Item Name: Crosstube Turning Detail

<b>DART AEROSPACE LTD</b>		<b>Work Order:</b>	101160
<b>Description:</b> Crosstube Assembly (205/212/412 High Fwd)		<b>Part Number:</b>	D212-664-141
<b>Inspection Dwg:</b> D212-664-141 <b>Rev:</b> D		<b>Page 1 of 2</b>

DRAWING NO. D212-664-141	TITLE XTUBE ASSY (205/212/412 HI FWD)	REV. D	DART AEROSPACE LTD ENGINEERING ORDER		D.E.O. NO. D212-664-141-D-1	SHEET NO. SHEET 1 OF 2	SCALE NTS
DRAWN	CHECKED	MP	MFG. APPR.	EC	APPROVED	NA	DE APPR
DATE 11.04.07	DATE 11.04.11		DATE 11.04.12		DATE 11/04/12		DATE 11.04.12

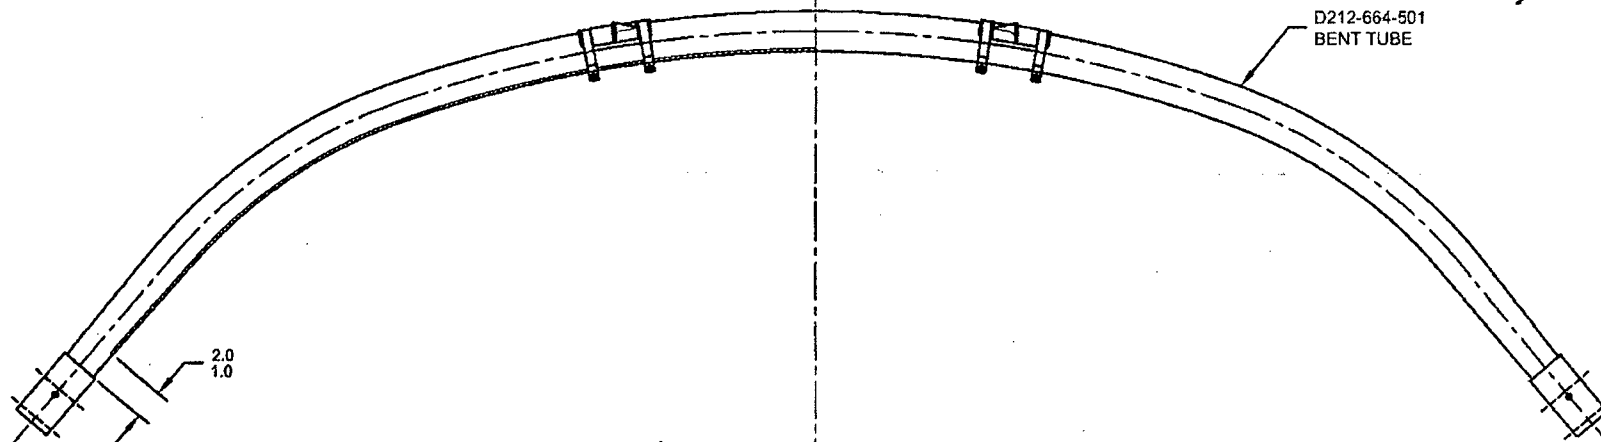
ADD AN INSPECTION WINDOW TO UNDERSIDE OF CROSSTUBE.

NOTES 2 OF SHEET 1 IS AMENDED AS FOLLOWS:

- 2) FINISH: CHEMICAL CONVERSION COAT PER DART QSI 005 4.1  
PRIME INSIDE AND OUTSIDE PER DART QSI 005 4.2  
MASK UNDERSIDE OF CROSSTUBE AS SHOWN (HATCHED AREA) AND  
PAINT OUTSIDE PER DART QSI 005 4.2  
REMOVE MASKING AND APPLY CLEAR COAT

**IS:****WAS:****UNDER REVIEW***9/11/06.13**ECN# 11-614**11.07.28*D212-664-501  
BENT TUBE**D212-664-141/-141B  
ASSEMBLY DETAIL**MASK AREA PRIOR TO PAINTING,  
REMOVE MASKING AFTER PAINT  
AND APPLY CLEAR COAT
